Item 3.**Development Application 16-22 Cooper Street, Surry Hills - D/2025/1198****File Number:** D/2025/1198**Summary**

Date of Submission:	2 December 2025 Final amended plans received on 15 April 2026
Applicant:	Michael Stokes
Architect/Designer:	SJB Architects
Owner:	STRATA PLAN No 65207
Planning Consultant:	Principle Planning
Cost of Works:	\$10,542,945.00
Zoning:	The site is located within the MU1 - Mixed Use zone. The use is defined as a "residential flat building", with "retail premises", and is permissible with consent within the zone.
Proposal Summary:	<p>Approval is sought for the demolition of the existing building, and construction of an 8-storey mixed-use development comprising retail tenancies on the ground floor, 2 levels of basement carparking, 10 residential apartments and associated landscaping.</p> <p>The application is being reported to the Local Planning Panel for determination as the development is for a new residential flat building and does not comply with the maximum building height development standard by 10%.</p> <p>The application seeks a variation to the maximum building height development standard under the Sydney Local Environmental Plan 2012. A maxi

Figure 23: 3D perspective of the proposed development showing the 27m height plane

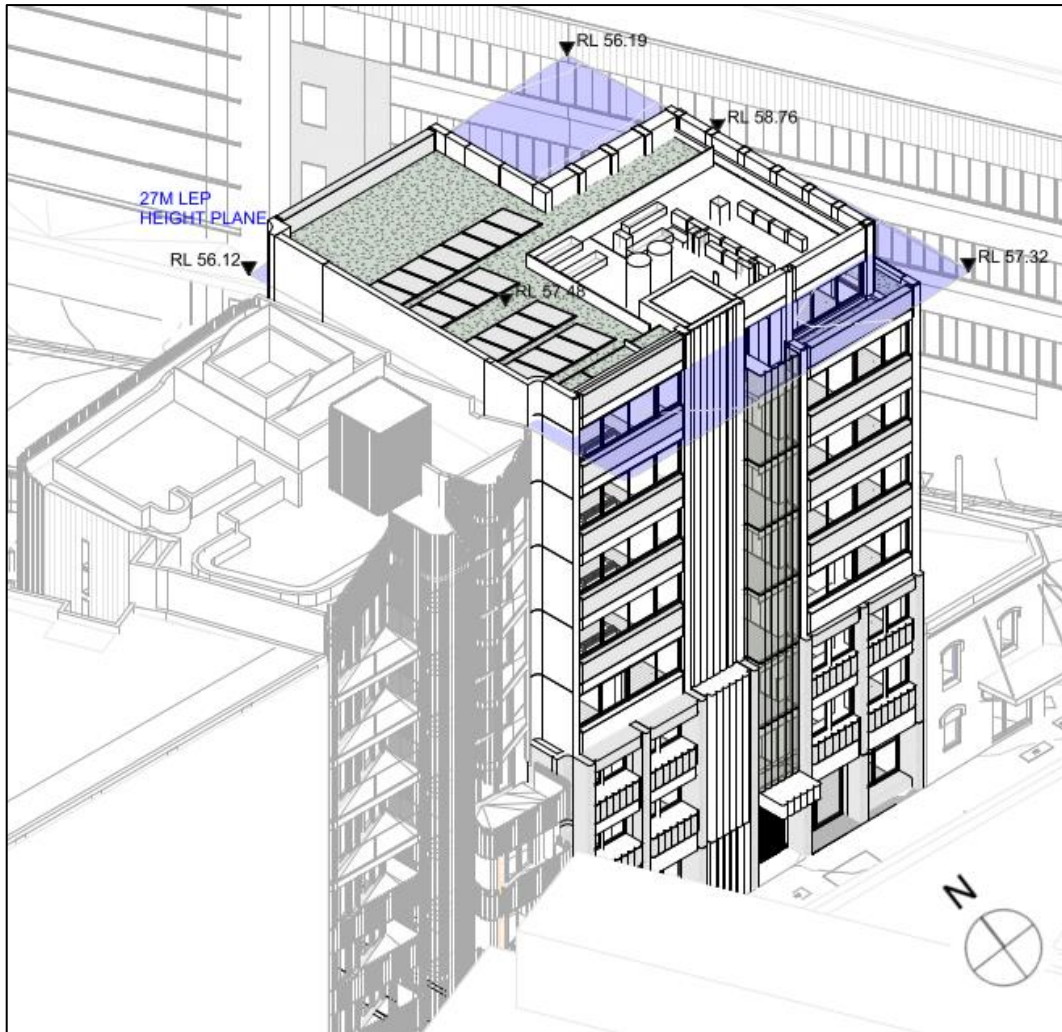
62. The site is subject to a maximum height control of 27m.
63. The proposed development exceeds the height control, with a maximum height of 29.7m above existing ground level to the top of the lift overrun and roof parapet (RL 58.76), resulting in a variation of 2.7m or 10% from the development standard.

Figure 26: Cooper Street elevation of the proposed building showing the 27m height control in red dash

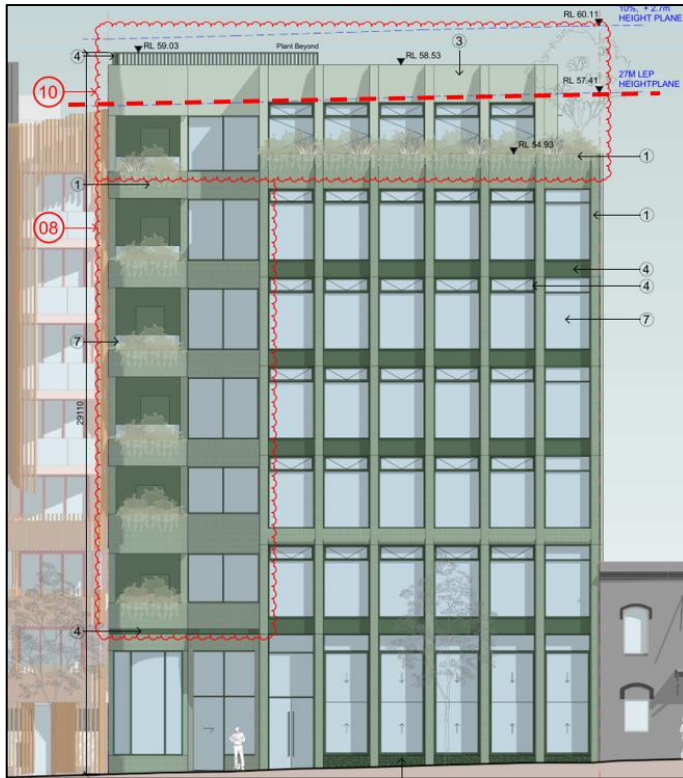
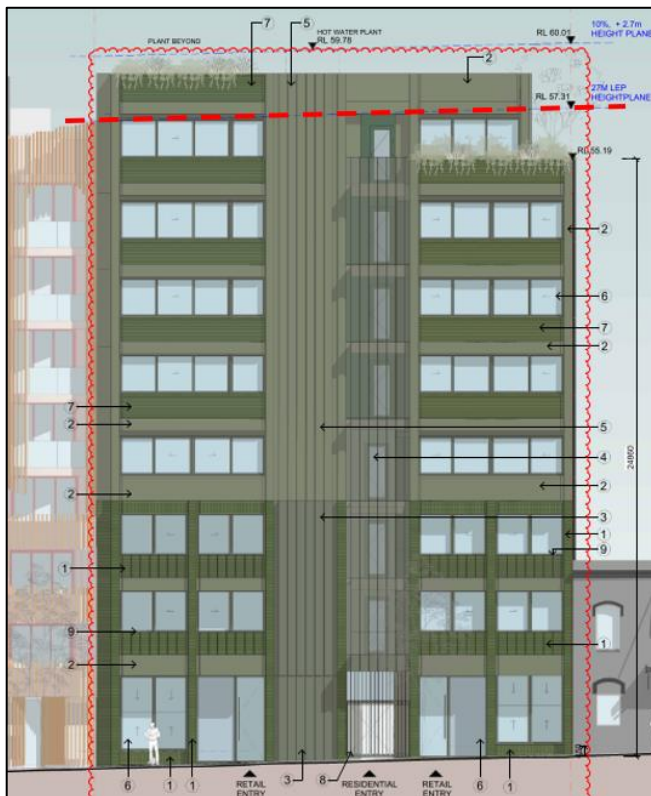
- (b) The overall height of the proposed development is generally consistent with the previously approved building envelope for a commercial building on the site under D/2023/904, which has a maximum approved height of 29.67m. A visual comparison of the proposed scheme against the approved building is provided in the below figure.

Figure 27: Ground floor plan showing the location of the communal area

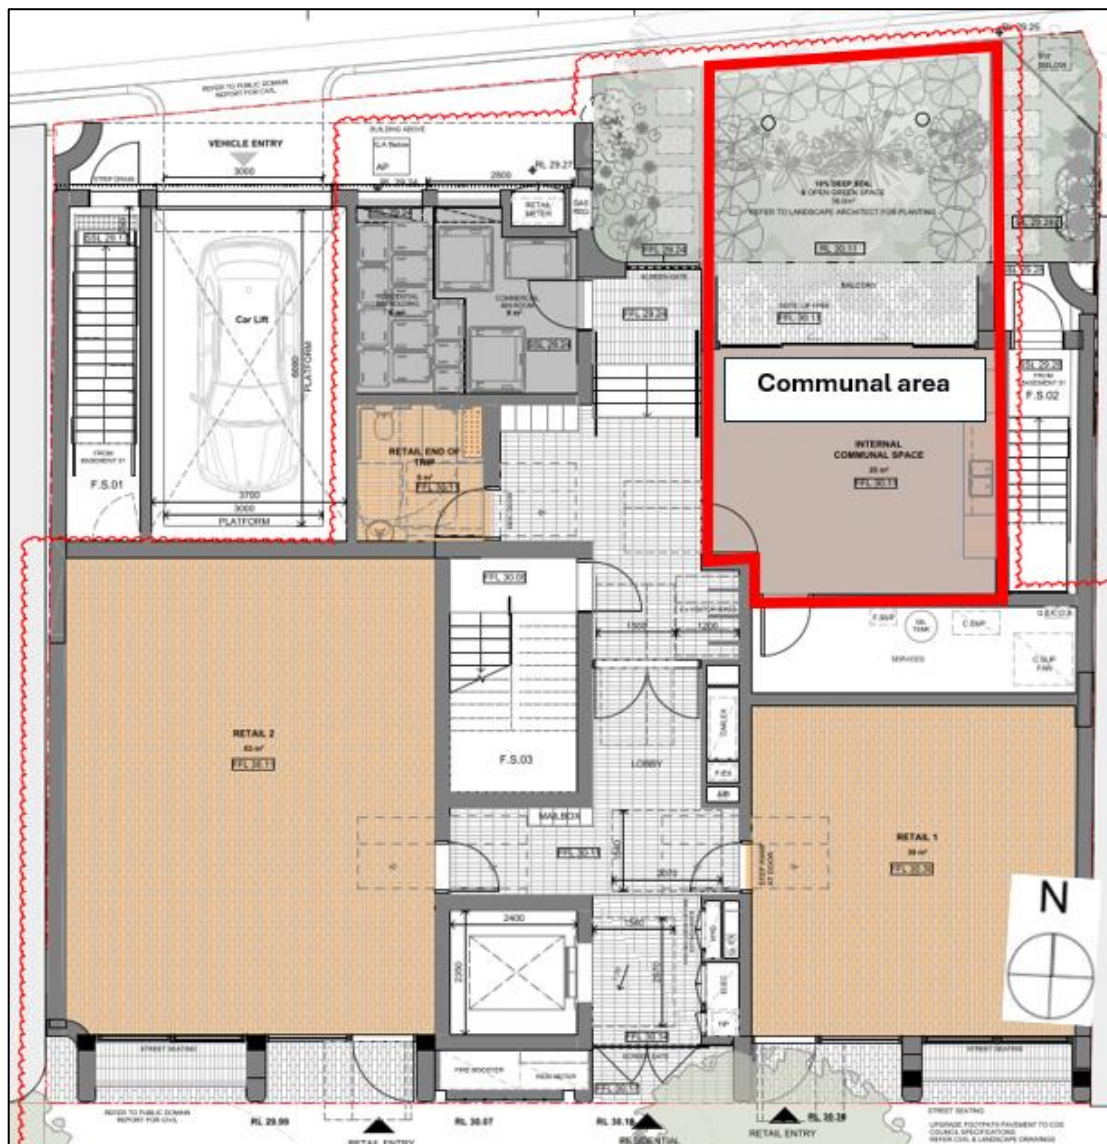
71. The proposed development includes a communal area at ground floor level in the north-eastern portion of the site. The communal area comprises an internal space of 25 sqm, and a landscaped outdoor area of 28 sqm, for a total area of 53 sqm, which equates to 14% of the site area. This area is outlined in the below figure.

75. Whilst the proposed communal area is under the minimum area required by the ADG by 43.5 sqm, the outdoor area incorporates landscaped deep soil area and includes an internal common room which features kitchen facilities and is directly adjacent to the accessible bathroom on the ground floor. In addition, all apartments feature private balconies that exceed the minimum area requirements of the ADG by between 4 and 45 sqm. The DCP controls also encourage communal open space at ground level, and only permit communal open space above ground level where it is not possible to provide ground level communal open space due to the site constraints, and where the proposed communal open space will achieve a similar amenity as at ground level and will not result in any significant loss of privacy to surrounding properties.

Figure 29: View from the sun diagram at 11am mid-winter

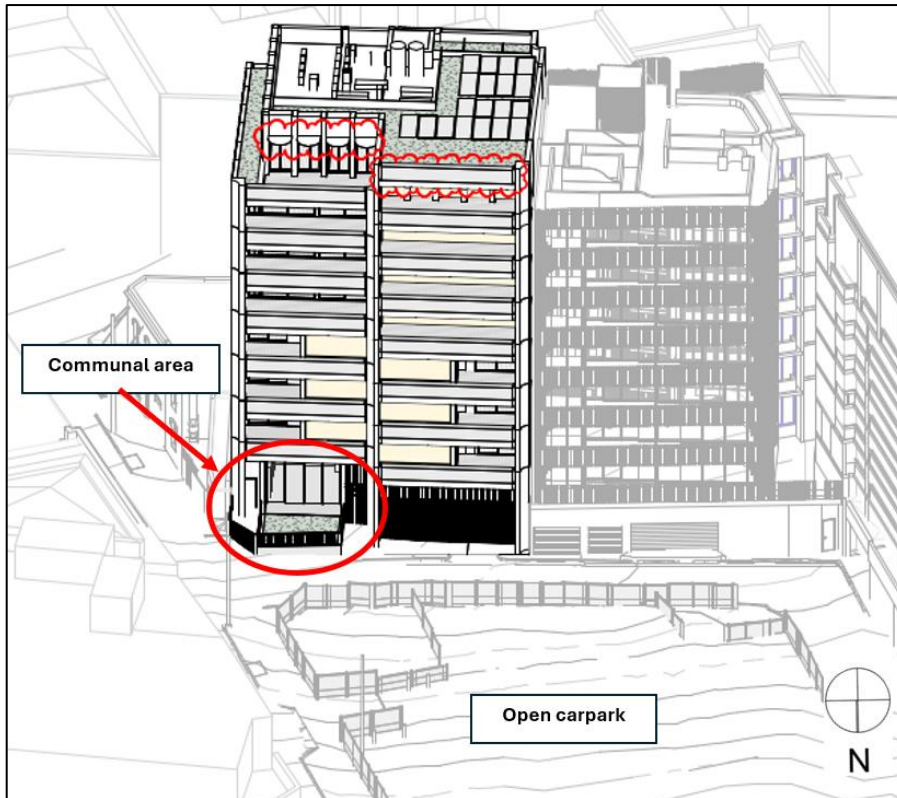
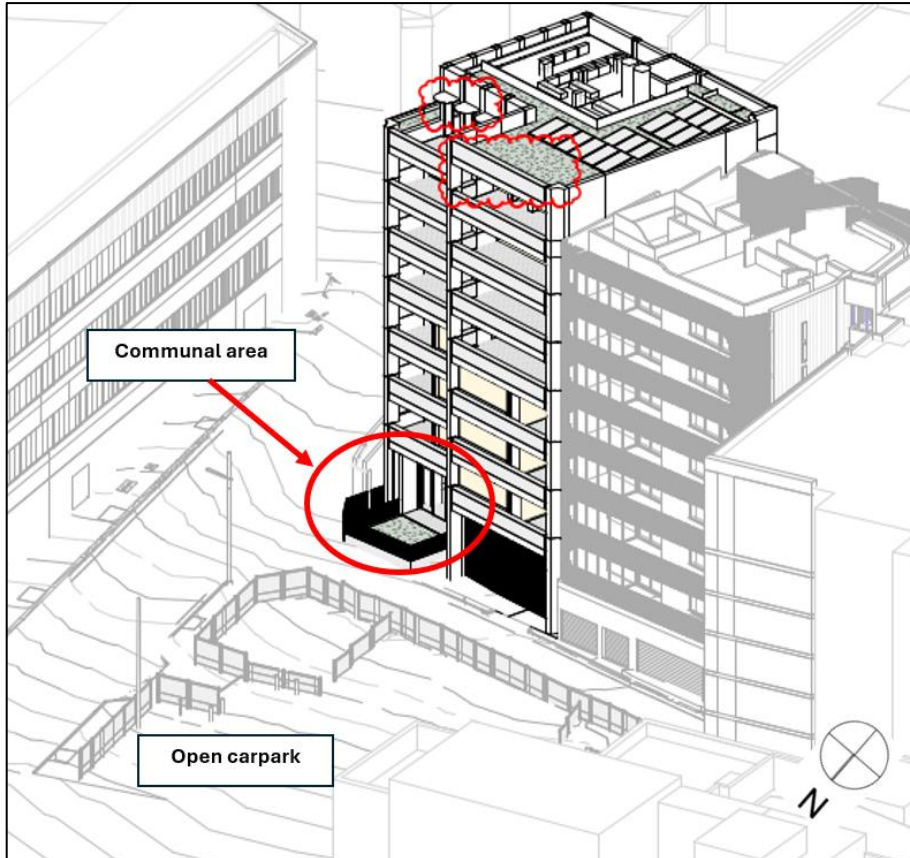
72. The submitted shadow diagrams indicate that the communal area will receive direct sunlight to at least 50% of both the indoor and outdoor space from 11am to 2pm mid-winter. Whilst this strictly complies with ADG requirements for solar access, it is noted that any future development of the open carpark to the north will reduce the amount of direct sunlight to the communal areas. This is demonstrated in the below figures.

Figure 31: Ground floor waste holding area fronting O'Loughlin Street

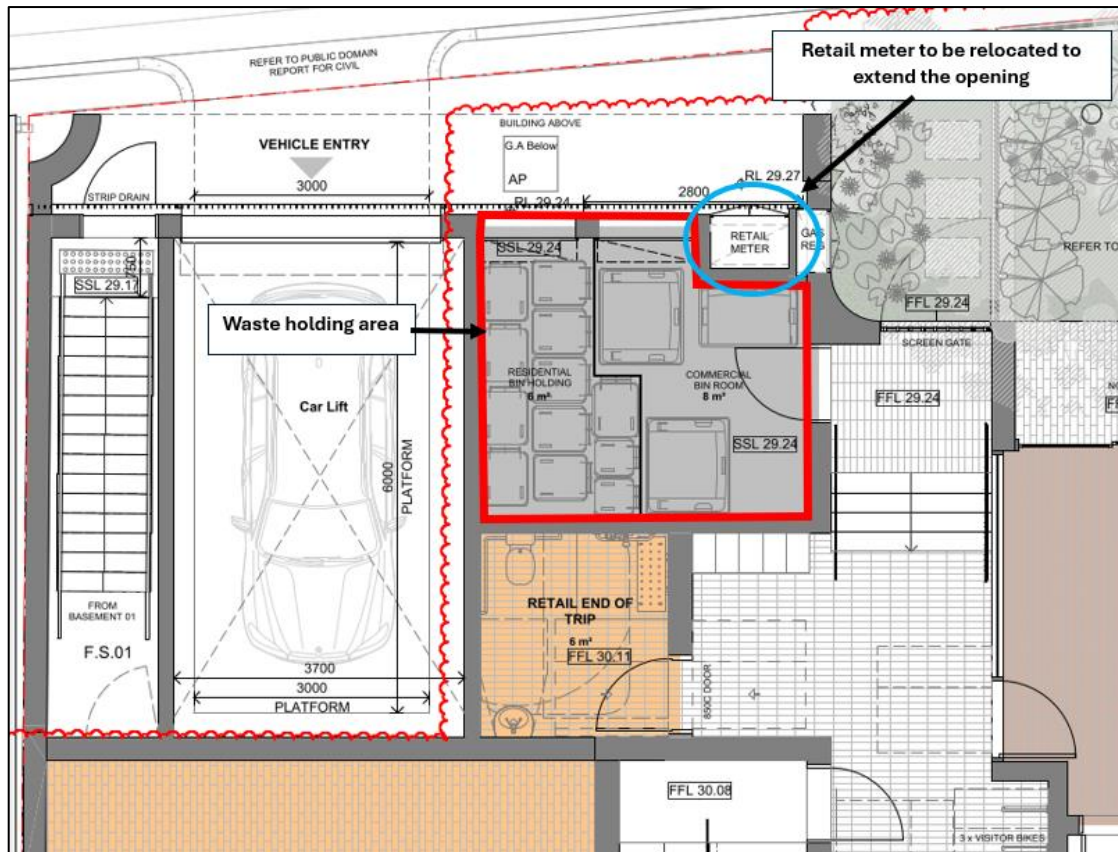
79. Council's Cleansing and Waste Management Team have advised that whilst the location of the waste holding area is acceptable, the space provided is insufficient to allow each waste stream to be wheeled out independently. As the 3 waste streams will not be serviced simultaneously, each stream must be able to be serviced independently without requiring bins to be moved or rearranged. A condition of consent is recommended requiring the waste holding area to be reconfigured and for the rear external opening to be widened by removing or relocating the retail meter, to allow for improved access and sufficient circulation space for each waste stream to be wheeled out and serviced independently. See below figure.

Figure 32: Cooper Street elevation, showing the change in architectural expression above and below the street wall

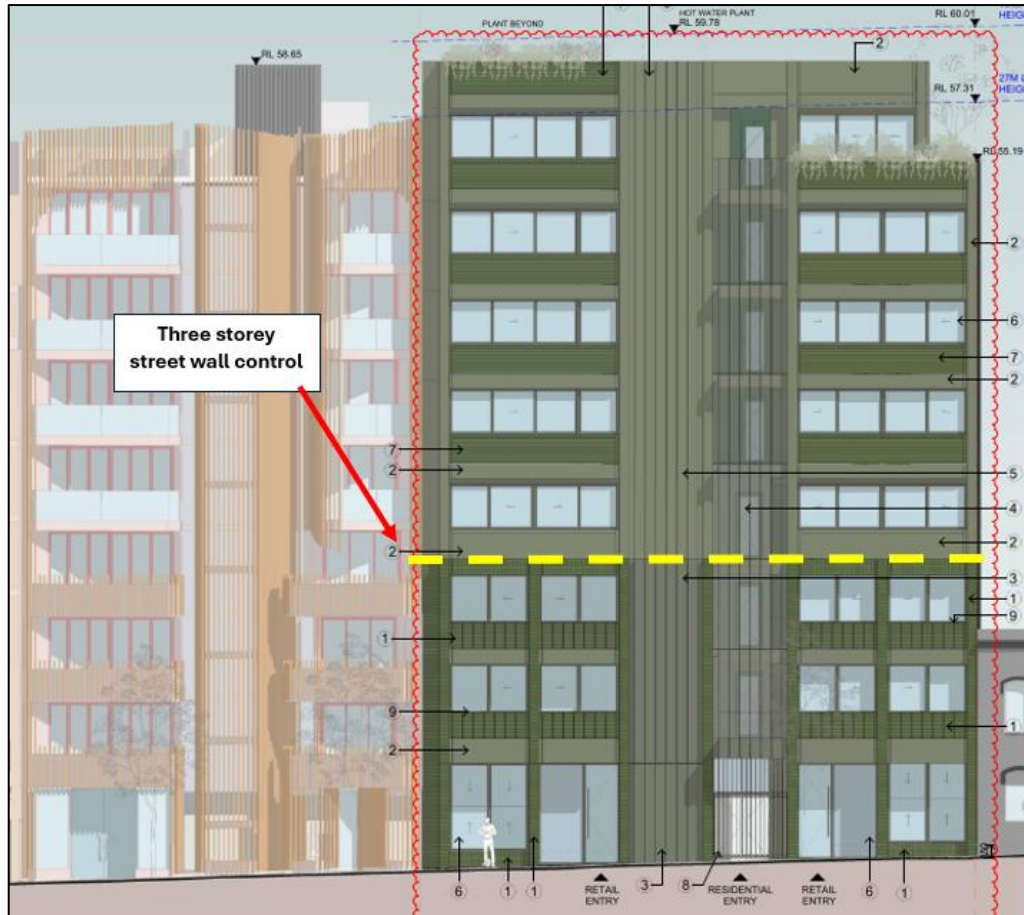
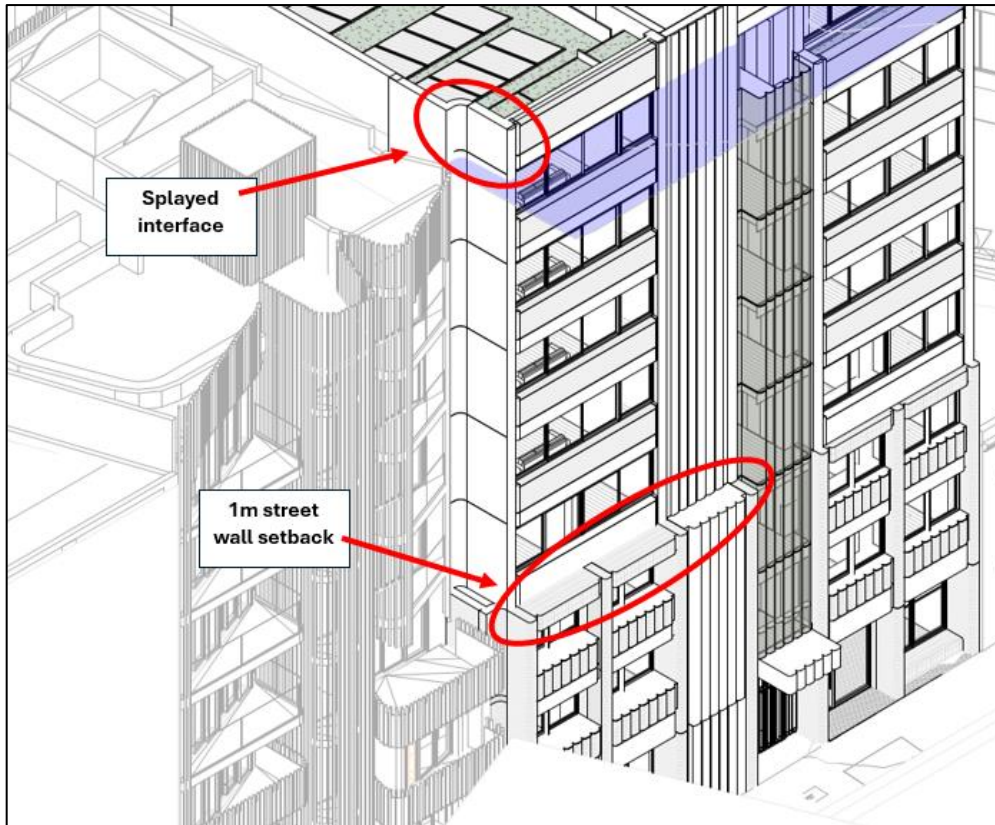
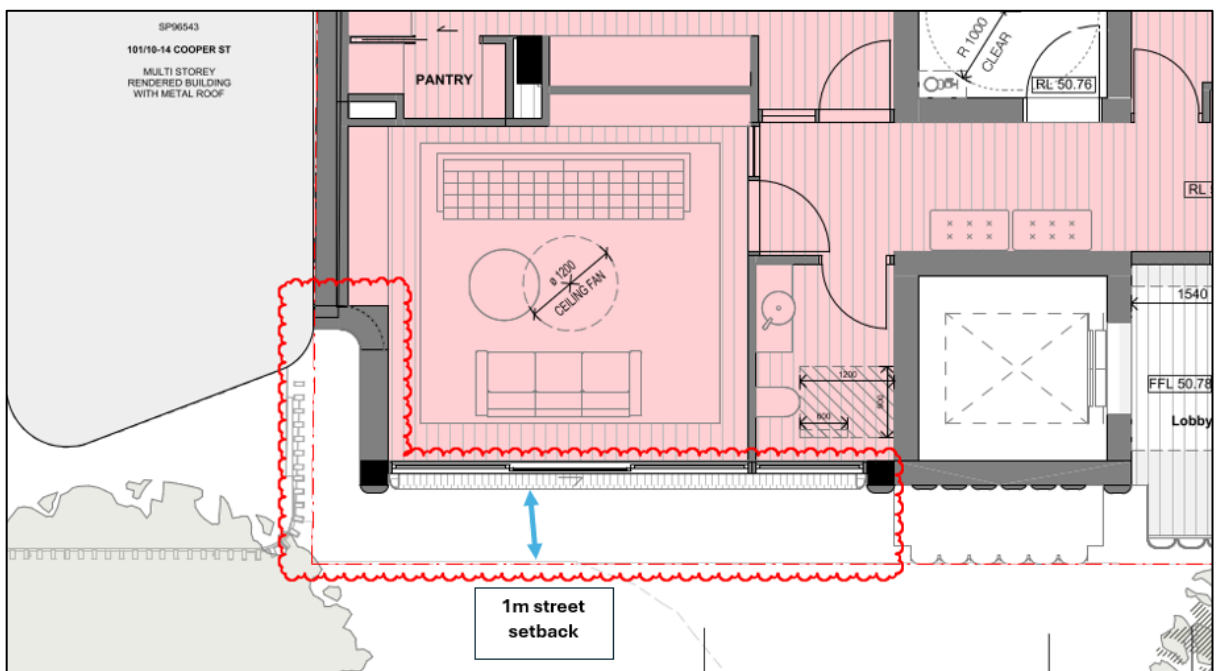
- (e) *The façade rhythm to Cooper Street appears complex and does not achieve the façade depth of the previously approved commercial building. Generally, the proposal for a fine vertical expression is supported; however, the façade design to Cooper Street should be further developed.*

Response: The materiality and architectural expression of the Cooper Street facade has been amended to better acknowledge the 3 storey street wall DCP control and respond to the street setbacks of the neighbouring building at 10-14 Cooper Street. The western portion of the Cooper Street facade is setback 1m from the street boundary above the 3 storey street wall and features a splayed interface with No.10-14 Cooper Street. This is demonstrated in the below figures.

Council's Urban Designer supports the facade design, subject to additional details being provided for the terrazzo window sills, and for the glazed green brick balustrades to incorporate a stone or masonry capping to the top of the balustrade. A condition of consent is recommended to capture these recommendations.
